License No: 49-09955-10
Docket No: 030-01776
Control No: 463146

September 24, 1993

RE: Sybille Environmental Assessment

Wildlife Holding/Handling Facilities

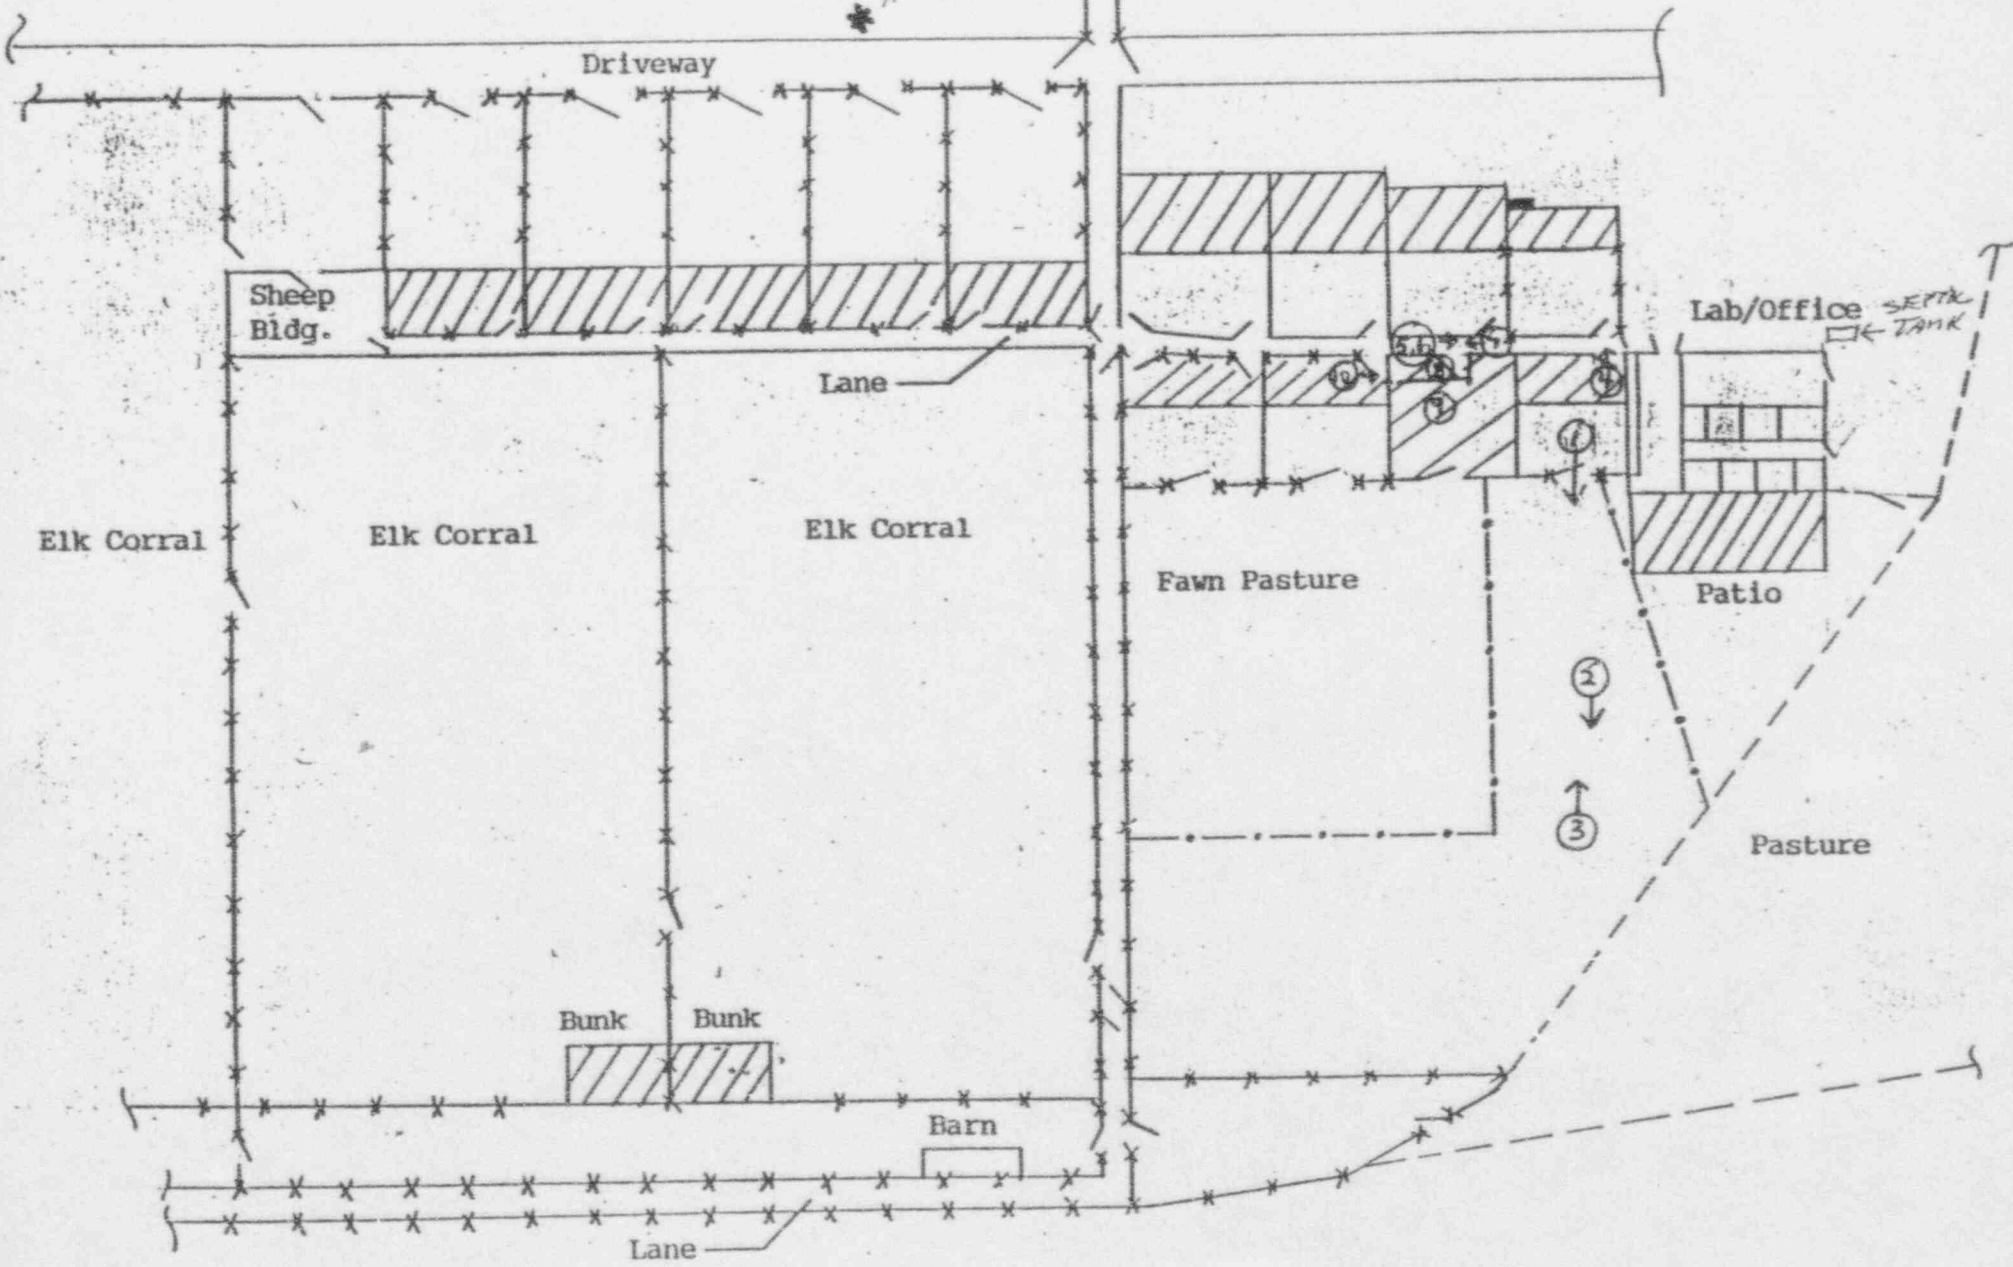
Need location of wells
and septic tank

depth?
geology? 0

WELL APPROX. 30' DEEP
